La Jolla Shores Planned District Advisory Board (LJSPDAB) APPLICANT PROJECT INFORMATION FORM

Subject: 8081 Calle Del Cielo, Assessment Letter; Project No. PRJ-1104216
Internal Order/Trust Account: IO: 24009698. La Jolla Community Planning
Association.

Site Development Plans, Akavan Residence, 8081 Calle Del Cielo San Diego, CA 92037, dated July 25, 2024

Site Development Plans PRJ-1104216.pdf

SHEET TITLE **PROPOSED EXTERIOR ELEVATIONS**

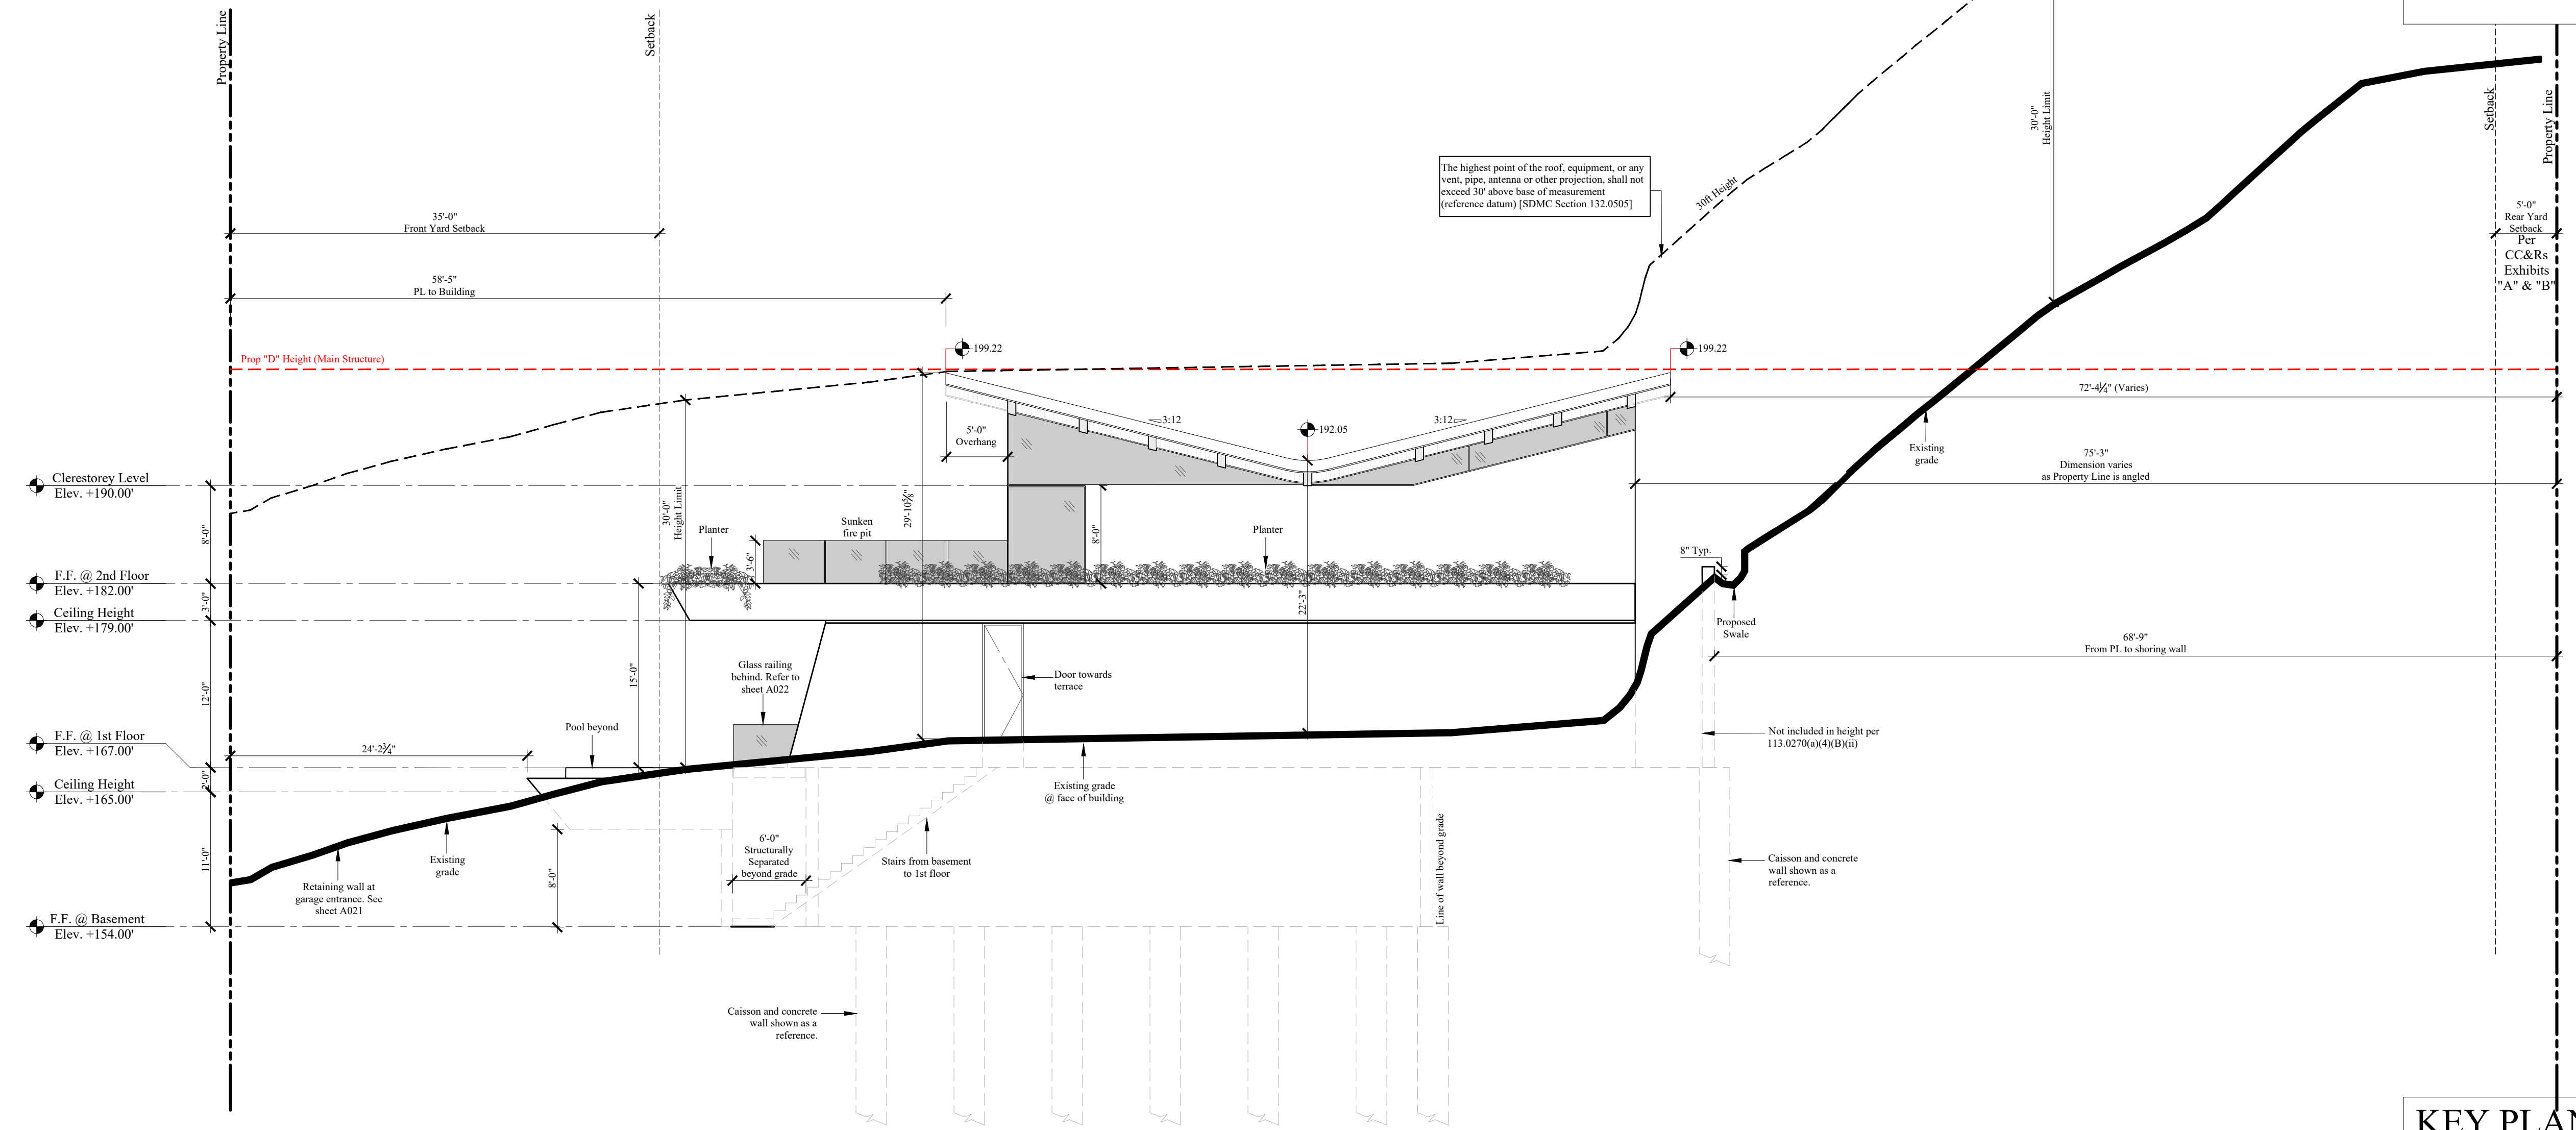
Please show existing and proposed grade on all elevations.

Plumb line height appears to be projected from the incorrect elevation point . Please revise to show 30 foot projection at the terrace level taken from adjacent grade, existing or proposed, whichever is lower.

C PROPOSED SECTION

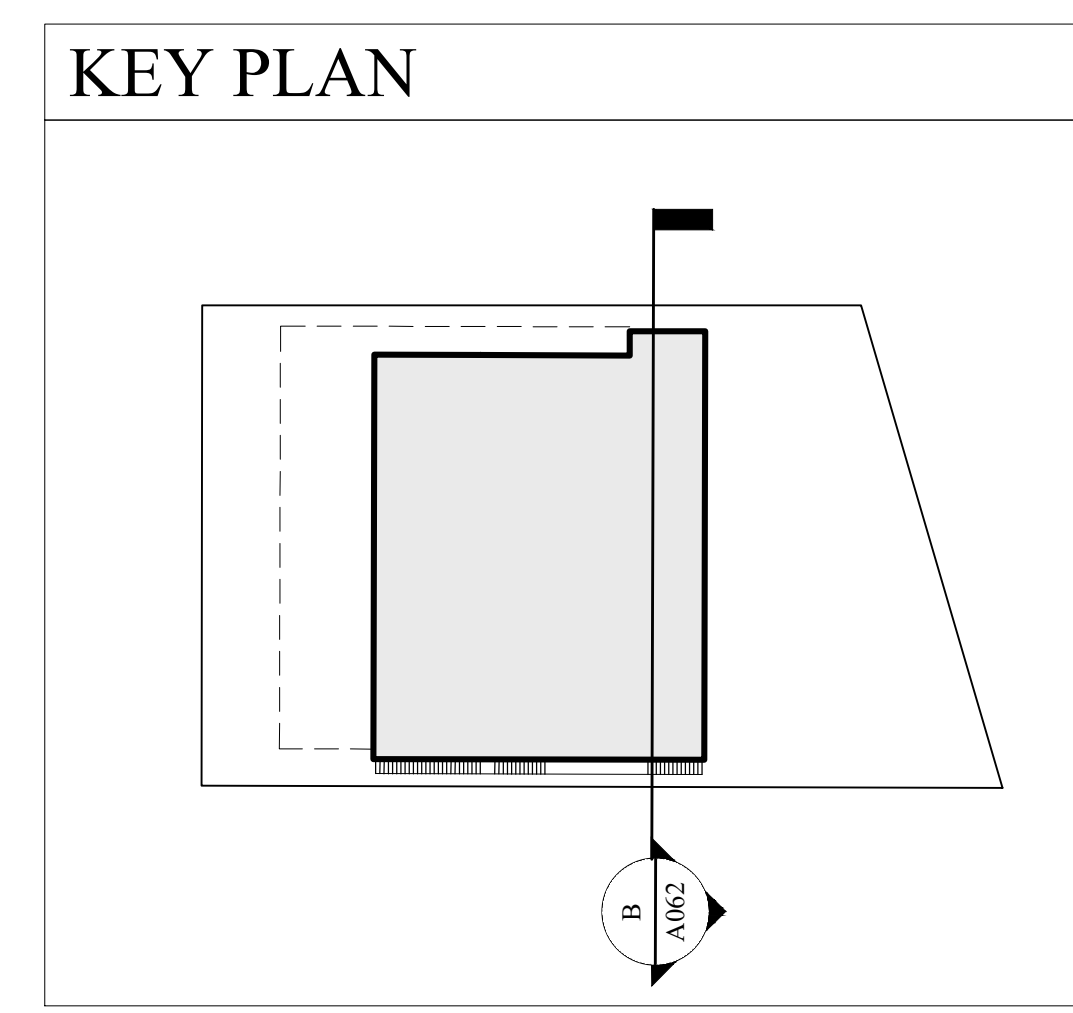
Upon resubmittal, please call out phantom floors on proposed Section C. Per SDMC113.0234(b)(4)(A), Include phantom floor square footage on title sheet and in FAR calculation.

SHEET TITLE **LANDSCAPE PLANS**

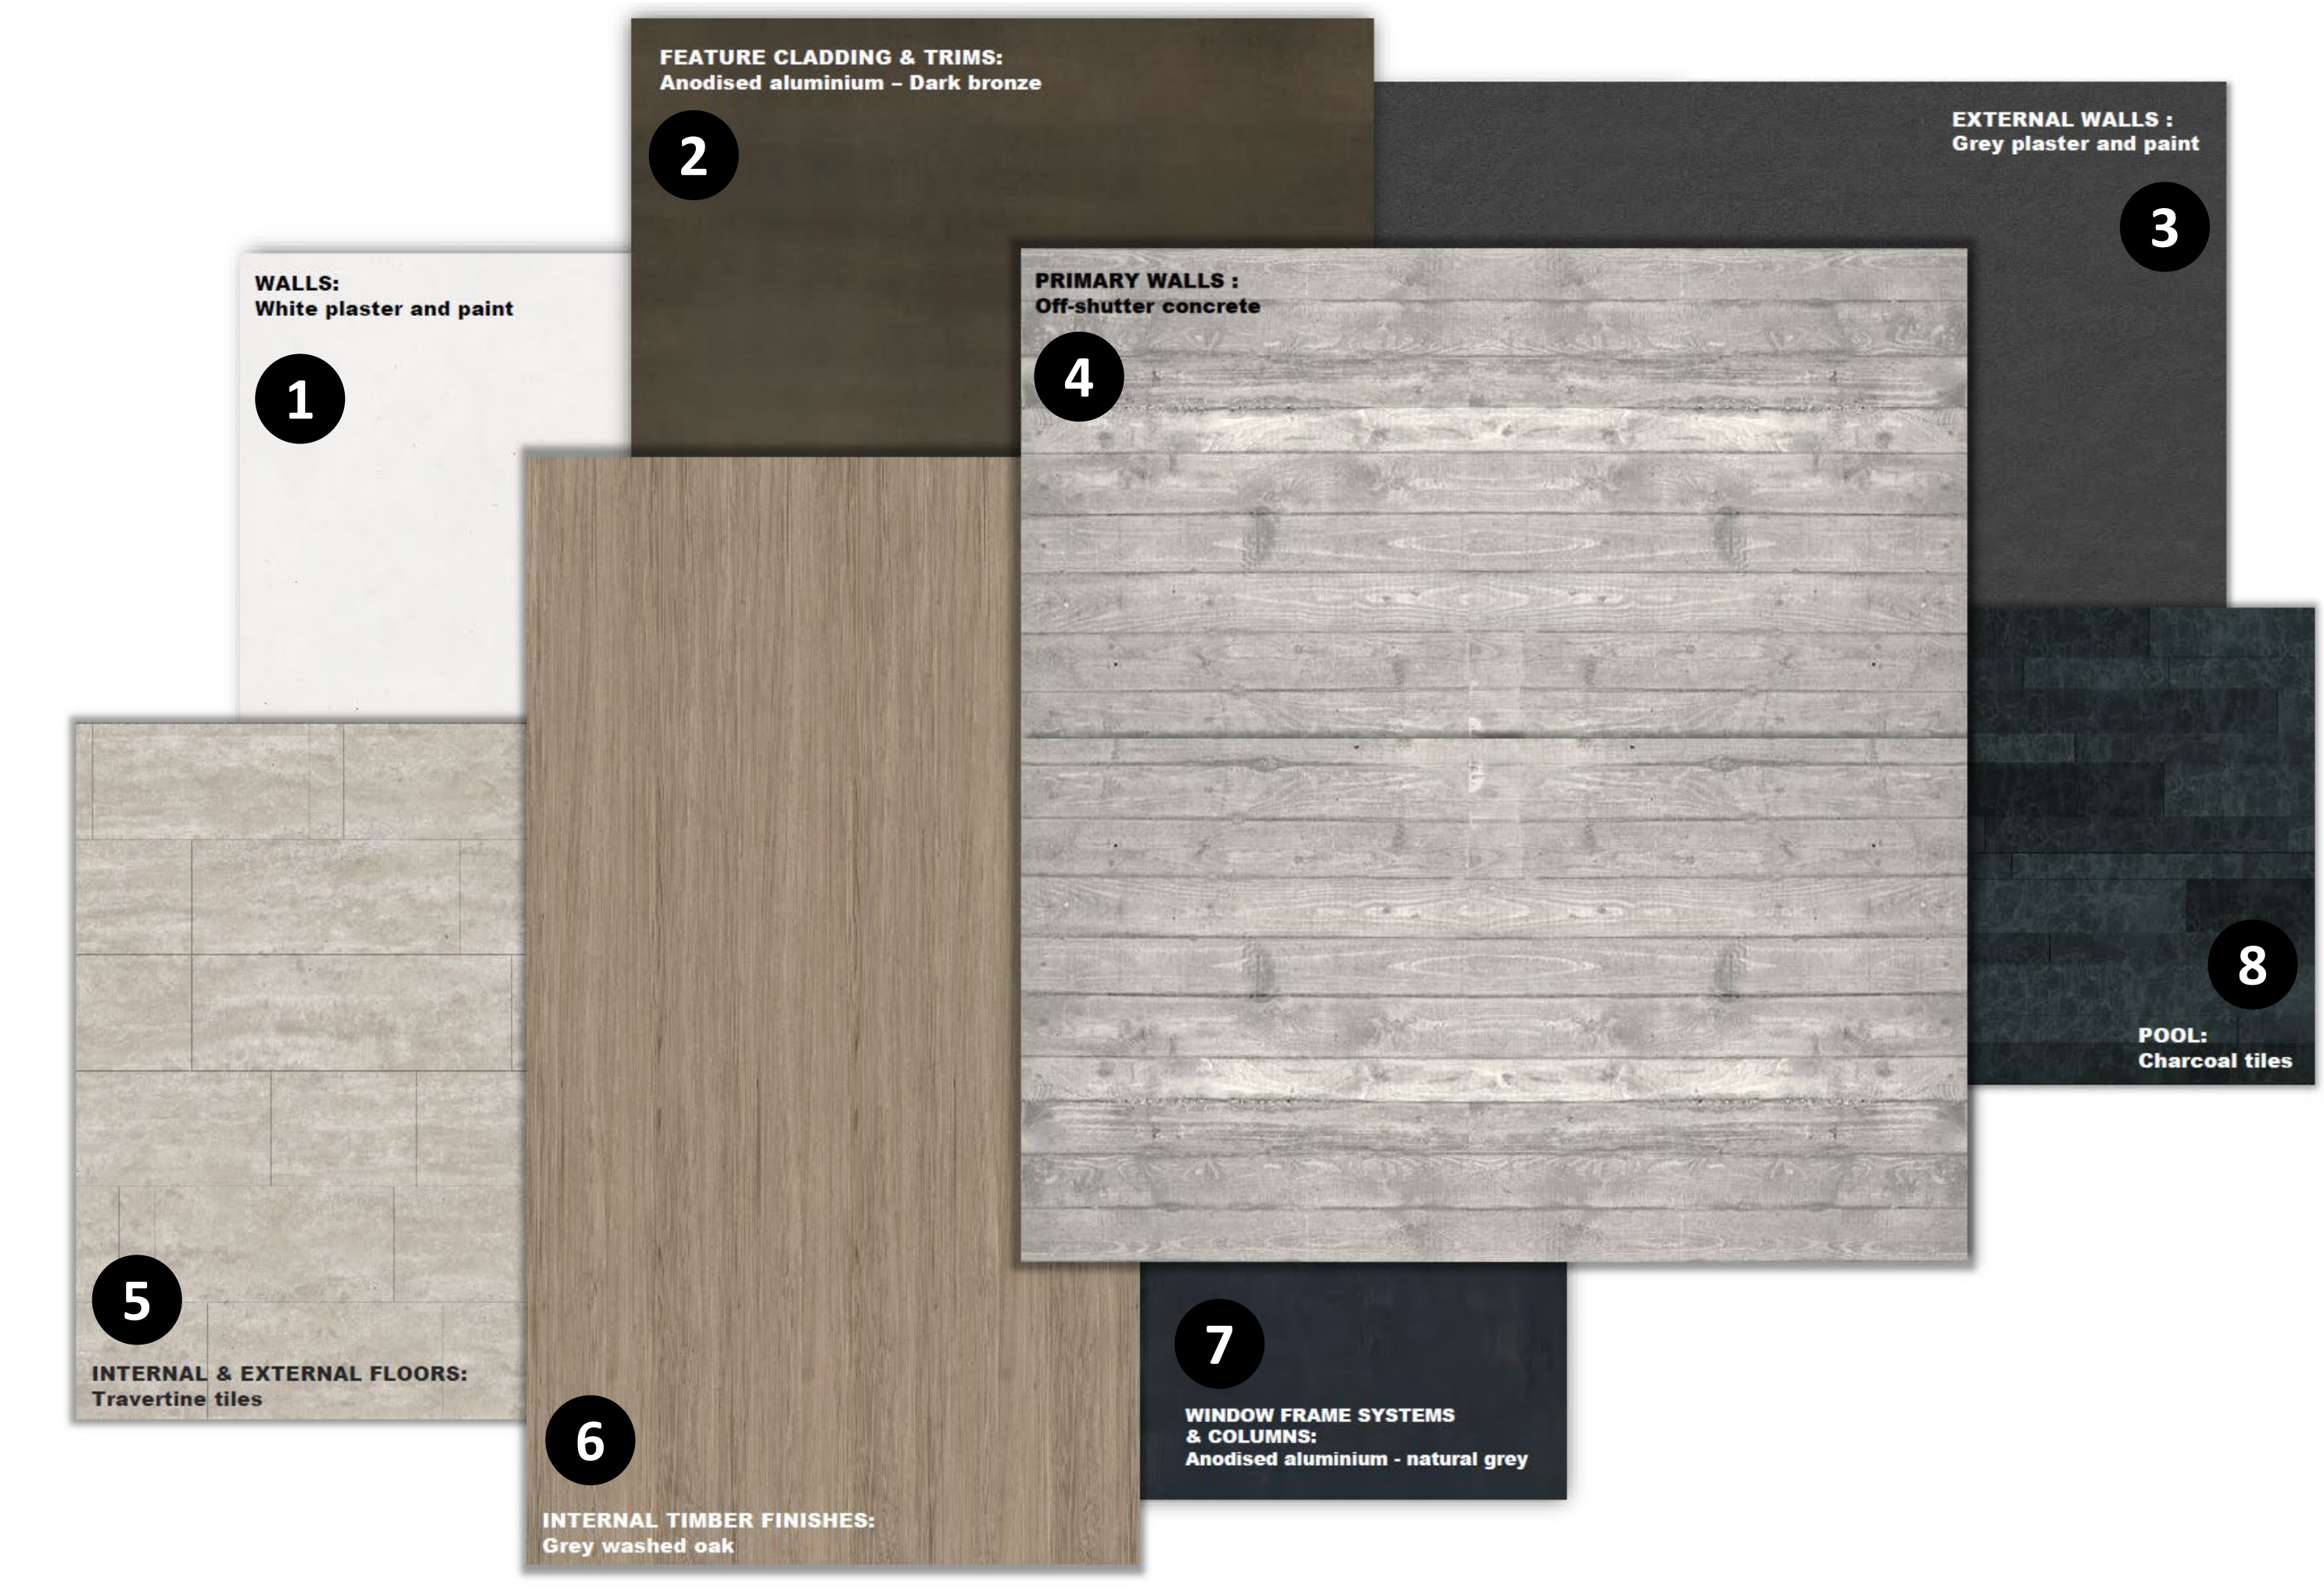
Complete Landscape Plans Required: Complete landscape plans are required in accordance with requirements in the Project Submittal Manual Section 4, Items 11.0-11.3.4, available online.

Brush Management Plan [Table 142-04A]: Due to the proximity to highly flammable native/naturalized vegetation, a Brush Management plan shall be provided in accordance with SDMC 142.0412. A formalized Brush Management program is required. Refer to the Project Submittal Requirements, Section 2A, Item No. 8 for all information required on a Brush Management Plan.

Brush Management Zones (Action): Typical Brush Management Zones consists of a 35-ft Zone 1 and a 65-ft Zone 2; however, for the project at hand non-standard zones apply. Per the FPB policy B-18-01, a minimum defensible space of 10 feet shall be provided for Zone 1. Please provide a minimum defensible space of 10 feet for a Zone 1 condition. Zone 1 shall measured from the habitable structure towards the rear property line. (Provide dimensions and label Zone as 'BM Zone 1'). Zone 2 will extend from the end of Zone 1 and onto the rear property line (Provide dimensions and label as 'BM Zone 2').

Brush Management, Alternative Compliance [142.0412(i) & (j)]: Because the site is not proposing a full fire defensible space (35' of Zone 1 and 65' of Zone 2) site requires alternative compliance measures to mitigate for the reduced Brush Management Zone. The proposed new openings shall meet fire-rating criteria set forth under CRC R337 in lieu of full Brush Management Zone(s). Alternative Compliance measures shall be authorized by the Deputy Fire Marshal (Fire-Plan Review).

Vegetation: Within each zone, show the proposed plant massing and the existing plant masses to remain along with locations of existing and/or proposed trees, demonstrating that they meet the zone criteria:
-Plants within Zone One shall be primarily low-growing and less than 4 feet in height with the exception of trees. Plants shall be low-fuel and fire-resistive.
-Trees within Zone One shall be located away from structures to a minimum distance of 10 feet as measured from the structures to the drip line of the tree at maturity.

Irrigation Information: Graphically identify and label the extents of irrigation system in the Zone One area. If an existing and functional system is to remain, note on the plan and show location of controller and valves. In lieu of a full irrigation system, hose-bibs within 50-ft of all Zone One areas shall be acceptable for this small scale, single-dwelling unit development. Identify all location of hose-bibs on the Brush Management plan.

Photo Documentation: Plot 5-7 photos, directly on the Brush Management Plan, that demonstrate the existing conditions of the rear yard as well as the condition of the vegetation onsite, with emphasis on the rear portion/slope of the site. Provide a photo key map that identifies the photos' location.

Provide the following note on the Brush Management Plan: "The Owner/Permittee shall schedule a pre-construction meeting on site with the contractor and the Development Services Department to discuss and outline the implementation of the Brush Management Program."

Provide the following note per FPB Policy B-08-1: "Brush management activities are prohibited within coastal sage scrub, maritime succulent shrub, and chaparral habitats during the breeding season of federally protected species, from March 1 to August 15, except where documented to the satisfaction of the City of San Diego that the thinning would be consistent with the conditions of species coverage described in the City of San Diego's MSCP Subarea Plan."

Provide the following note: "All Landscaping / Brush Management within the Brush Management Zone(s) as shown on these plans shall be the responsibility of ___owner_____. The Brush Management Zone areas shall be maintained free of debris and litter and all plant material shall be maintained in a healthy growing condition."
